Release of WaterGuard VI

OASIS is in the process of replacing FreshGuard with WaterGuard VI (see diagram below). This new “no spill” device will function with bottle caps in exactly the same way as FreshGuard.

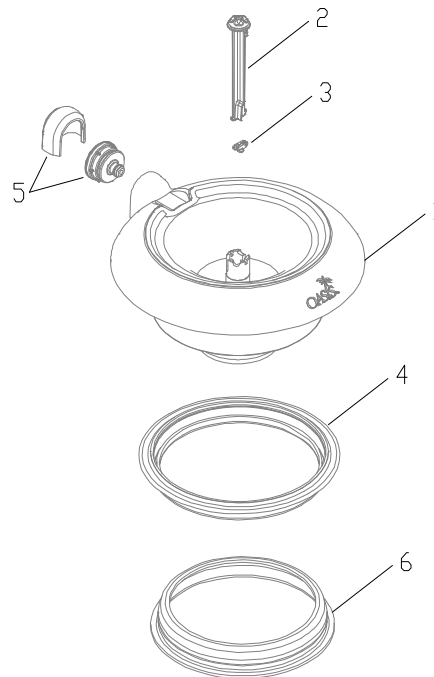
Please note WaterGuard VI will retrofit all previous generations of OASIS bottled water coolers.

The major advantage of WaterGuard VI is that the air filter has now been relocated outside of the main body of the device – any water spills during bottle changing will not enter the filter media.
